Service Letter No. 073

## TA04 & TA36 Turbocharger Left-Hand Thread Turbine Wheel Assembly Change Notification

**Turbine Wheel Assembly (Itm# 12) and Compressor Wheel Nut (Itm# 9)  
Figure 1.1**

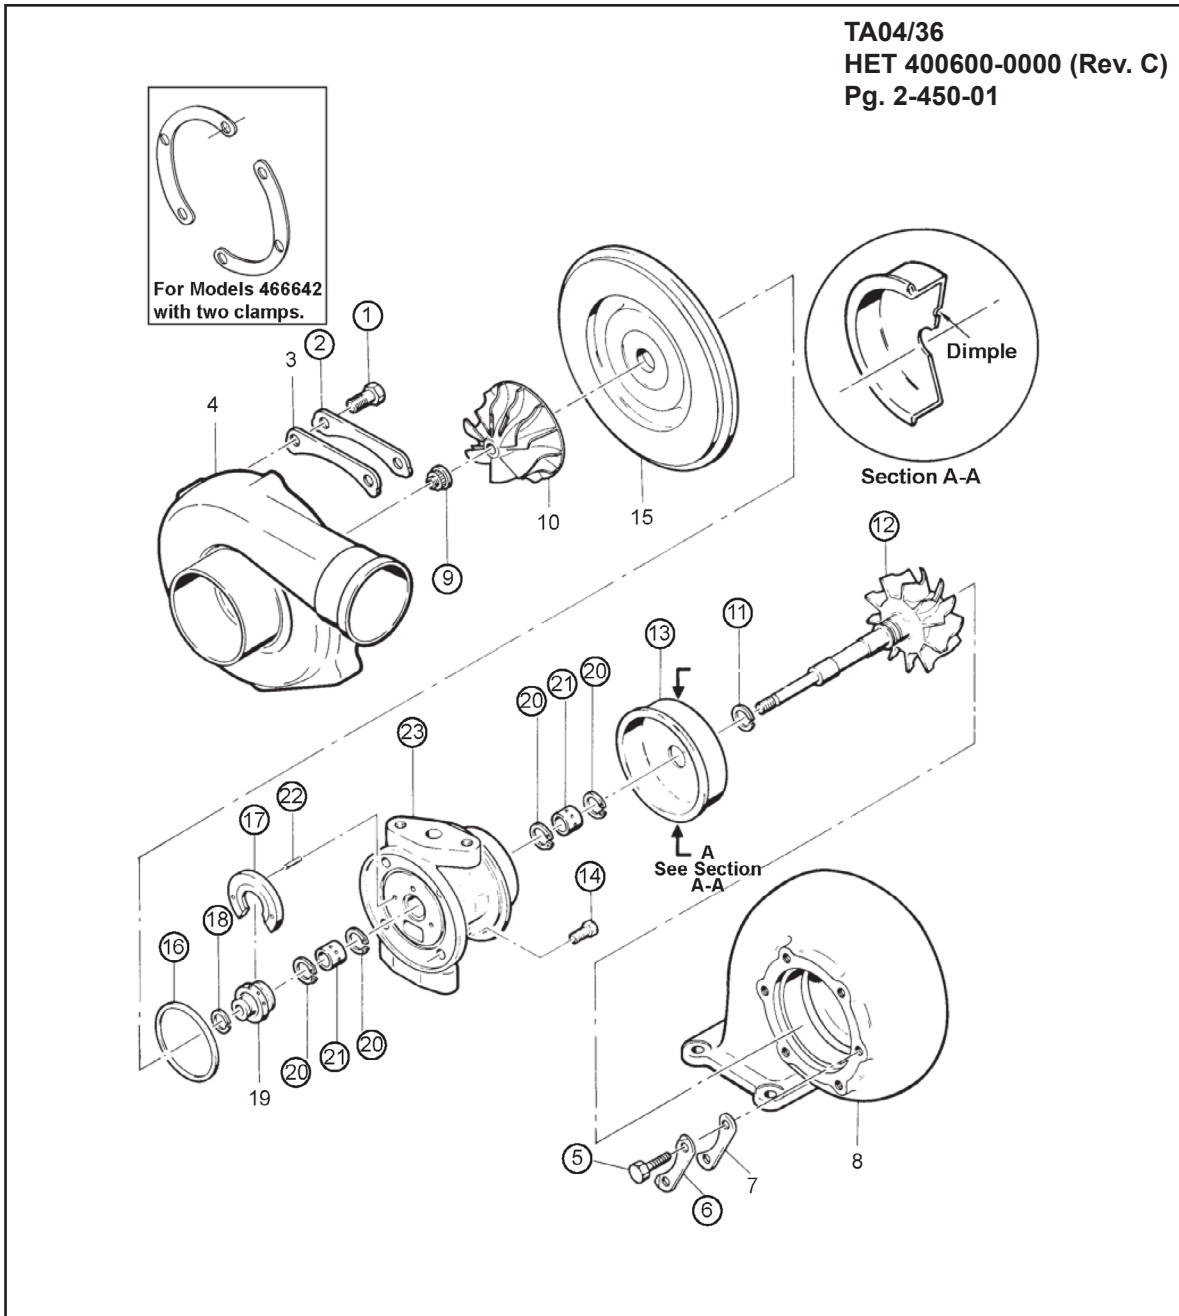
- (1) This Service Letter addresses affected turbocharger part numbers that have a design modification which changes the affected Turbine Wheel right-hand thread assembly and Compressor Wheel Nut to a Turbine Wheel left-hand thread assembly and Compressor Wheel Nut. See **Figure 1.1** for Turbine Wheel Assembly and Compressor Wheel Nut illustration.
- (2) Turbine Wheel Assembly P/N 407276-0006 and -0019, P/N 410188-0019, P/N 410188-0025, P/N 410188-0028 and corresponding Compressor Wheel Nut, P/N 400768-0011 are superseded when current Turbine Wheel inventory is exhausted. Existing unused inventory remains suitable for sale and use.

**NOTE:** Turbine Wheel Assembly and Compressor Wheel Nut original part numbers are superseded when right-hand thread inventory is exhausted.
